NUMBER: 18-031-03

THIS BULLETIN SUPERSEDES TECHNICAL SERVICE BULLETIN 18-027-02, DATED SEPTEMBER 06, 2002, WHICH SHOULD BE REMOVED FROM YOUR FILES. THIS IS A COMPLETE REVISION AND NO ASTERISKS HAVE BEEN USED TO HIGHLIGHT REVISIONS.

4.0L Rough Engine Idle After Restart Following A Hot Soak

This bulletin involves the installation of a fuel injector insulator sleeve.

Fig. 1 SLEEVE INSTALLATION

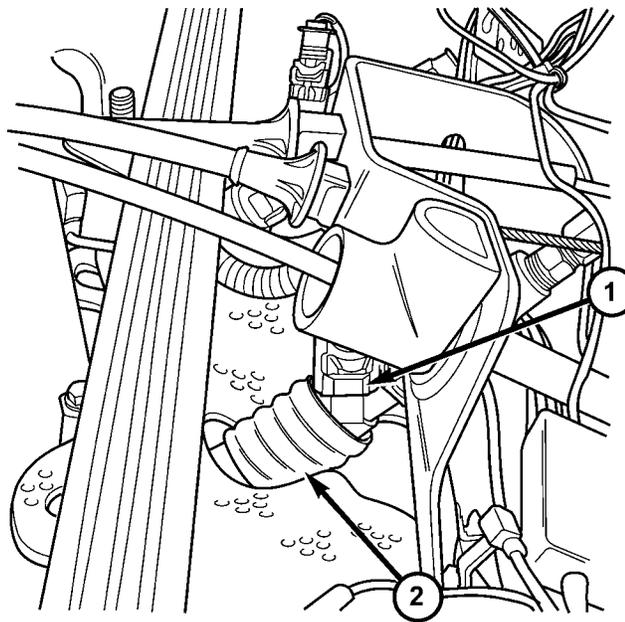
This condition may be caused by heat from the exhaust manifold that following engine shut down migrates to the area around injector #3 and causes fuel vapor to form within the injector. This in turn may cause a momentary misfire of cylinder #3 until the fuel vapor is cleared of injector #3. The insulator sleeve lowers the injector #3 temperature to a point below which the fuel will not normally vaporize.

1. If vehicle exhibits a rough idle, and if a misfire of cylinder #3 is observed following a 10 to 20 minute hot soak, perform the Repair Procedure.

1. Cut insulator sleeve, p/n 56028371AA, to make two (2) insulator sleeves about 25-30 mm (1 in.) in length.
2. Install one sleeve around injector #3, with the slit on the upward facing side of the injector. Install the other sleeve with the slit on the downward facing side of the injector.
3. Confirm sleeve is flush to intake manifold surface around injector.
4. Check injector #3 wire and ensure that the injector is rotated to a 2 o'clock position (from driver's side of vehicle).
